D.H.O. FOUNDATION INVESTIGATION  
(W.P. 244-60) -- W.J. 60-7-32.

Re: Hwy. 500 at Pusey and Grace Lake Junction,  
Township of Cardiff, District No. 11.

Re: Wilberforce Bridge Site, Contract 78-08

CONTRACT No.: 78-08

# Measured Pile Movements Contract 78-08

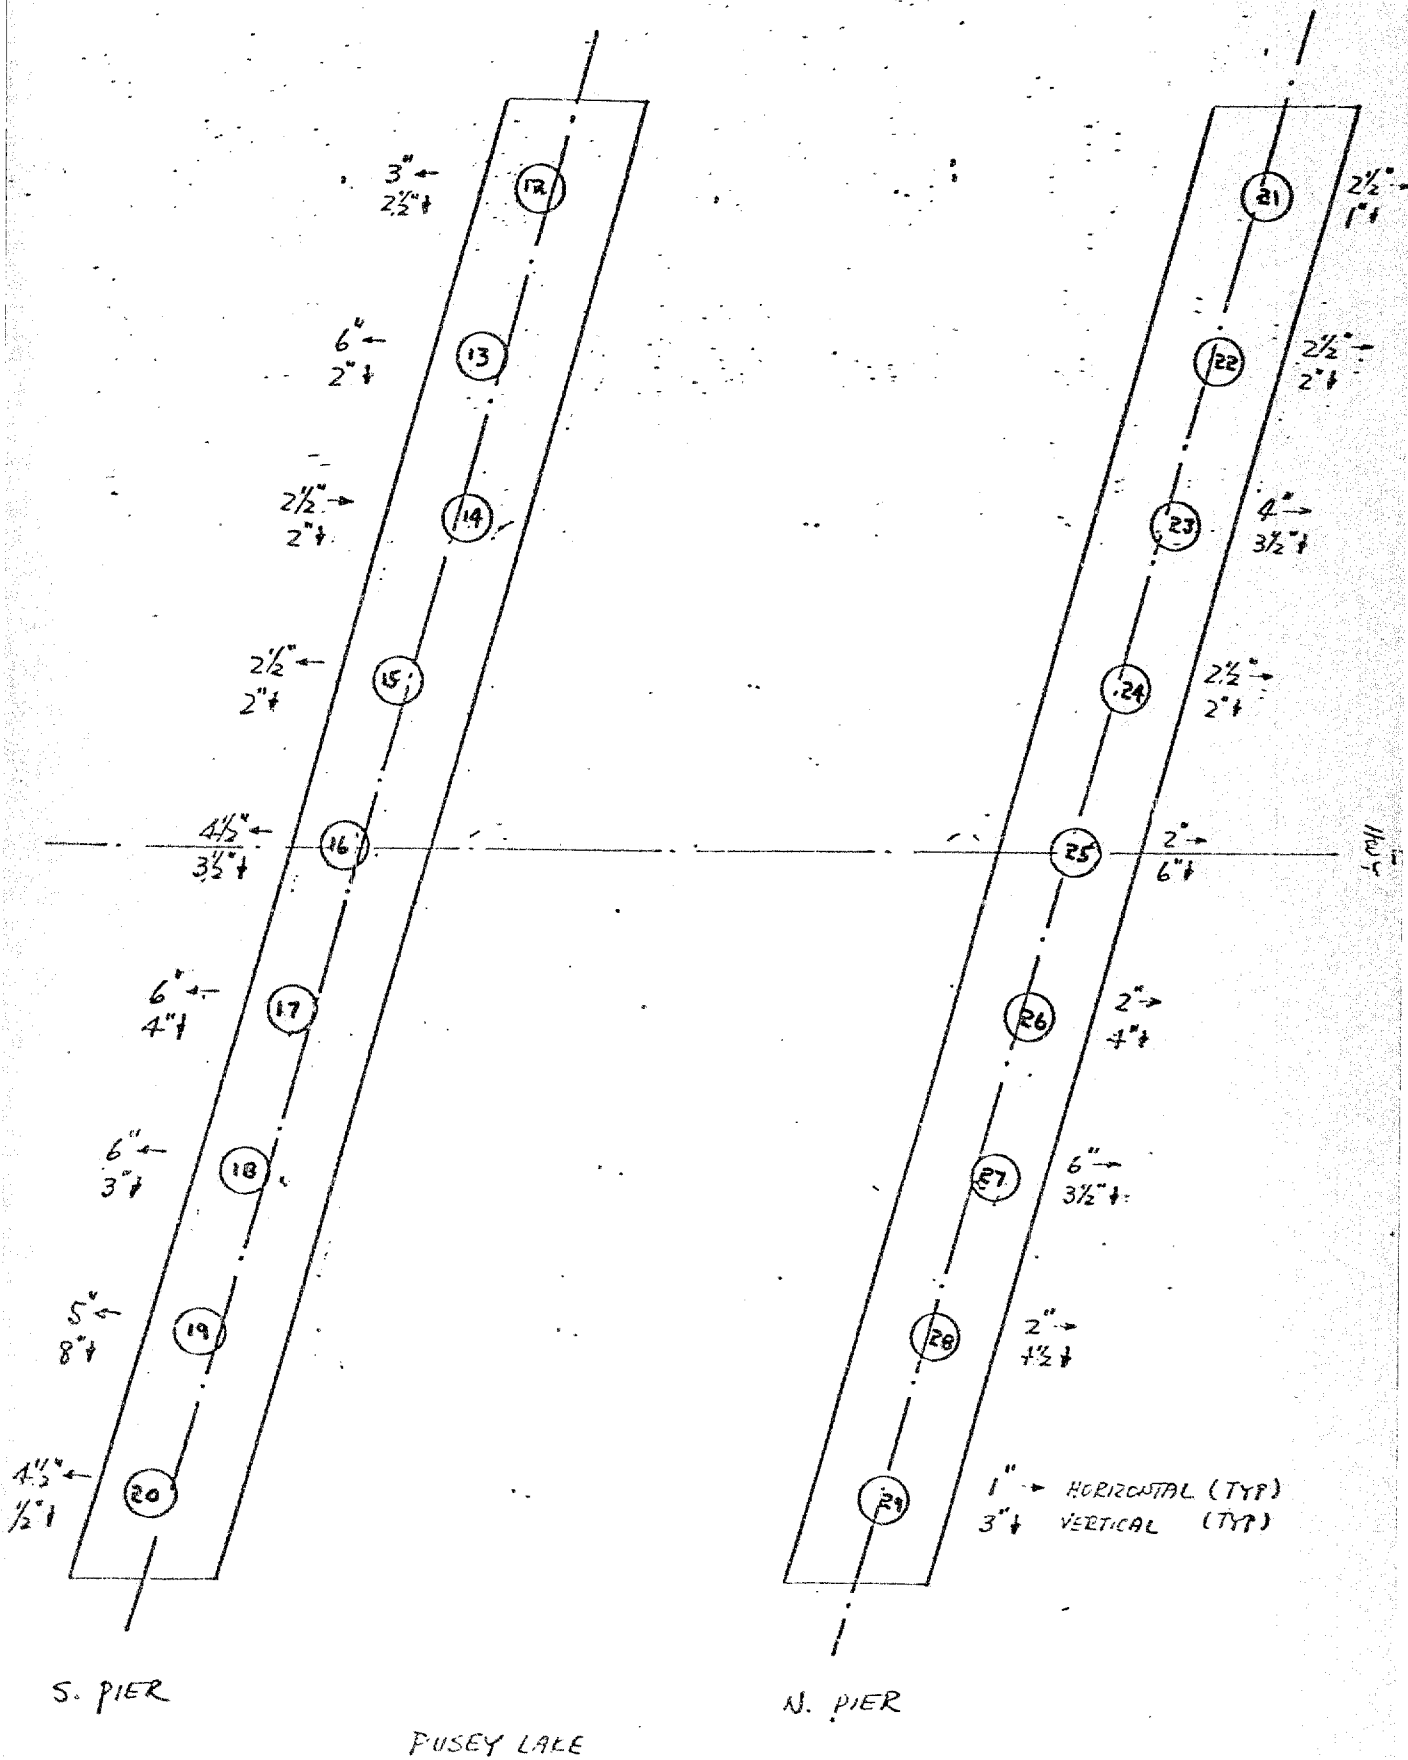
- i) The pile butts of the south pier bent had moved laterally towards the south abutment and settled vertically. Likewise, the north pier piles had moved towards the north abutment and settled. The magnitude of movements are shown on the attached diagram. Tension cracks in the soil surrounding the pier piles indicated the piles had moved laterally towards the abutments.
- ii) The author could not inspect the abutment piles since the pile caps had already been poured and the south abutment wall was in the process of being poured.

Considering the magnitude of lateral and vertical movement of the pier piles and the sensitivity of the structure to differential settlement, concern was expressed whether the piles would settle excessively under the design loading.

Since no unusual movement or problems of the abutment piles were reported by the construction field staff, we feel these piles will behave as designed. In order to verify the load-movement behaviour of the displaced pier piles, it is recommended to carry out a full scale load testing program on selected pier piles.

## Ultimate Bearing Capacity of Test Piles

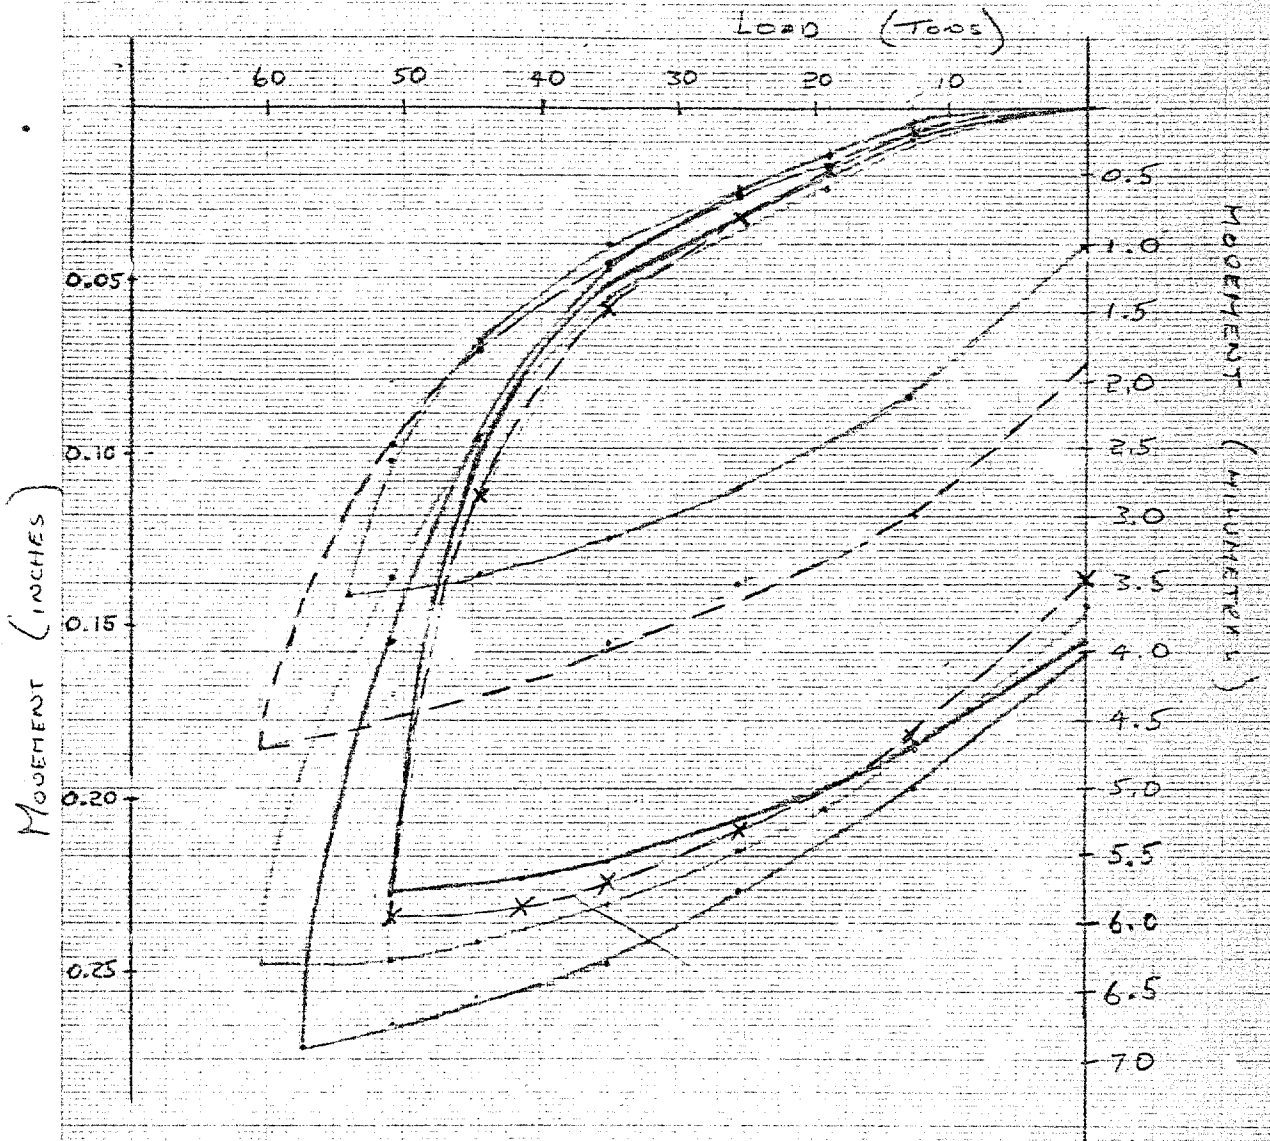
Based on the results of the pile load test, we feel that the ultimate bearing capacity of the pier piles can be conservatively estimated at approximately 45 to 50 tons with a maximum pile movement of 6.0 mm (0.25 inches) and net settlement of 4.0 mm. The safe allowable design load per pile should be limited to 22.5 tons which would result in negligible elastic pile movements in the range of 1 mm.

Due to the shift in the centerline of the pier caps and eccentricity in loading of the piles as a result of the batter of the various piles, we feel that the original pier cap drawings should be reviewed by your office and redesigned as required. We trust that the above information will be sufficient for design purposes and, hence, have no intention of submitting a formal report.

REVISED  
&  
PIER

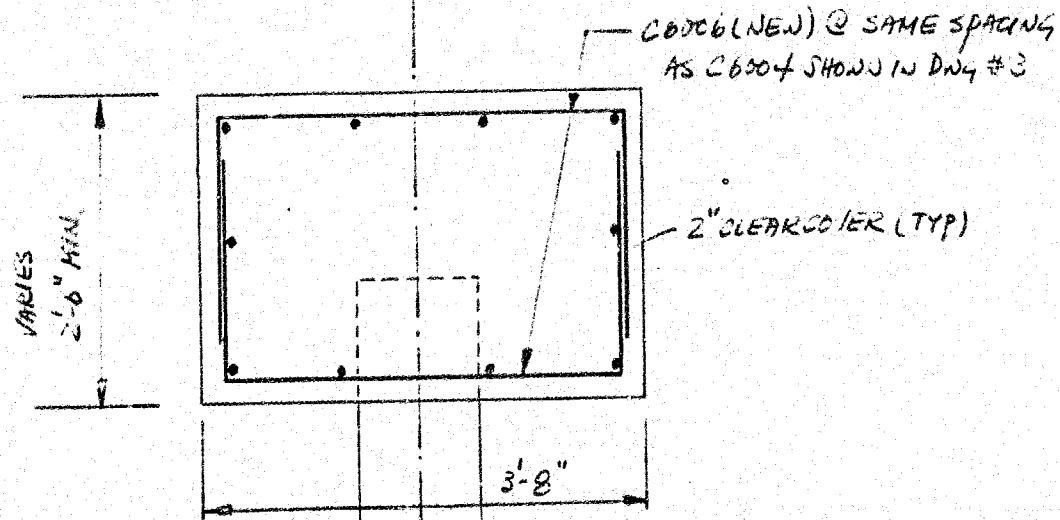
The width of the pier caps were then changed from 3' 0" to 3' 8" wide at this time.

The extra concrete required by this change was paid for under Quotation Request #Q-40-78-58.
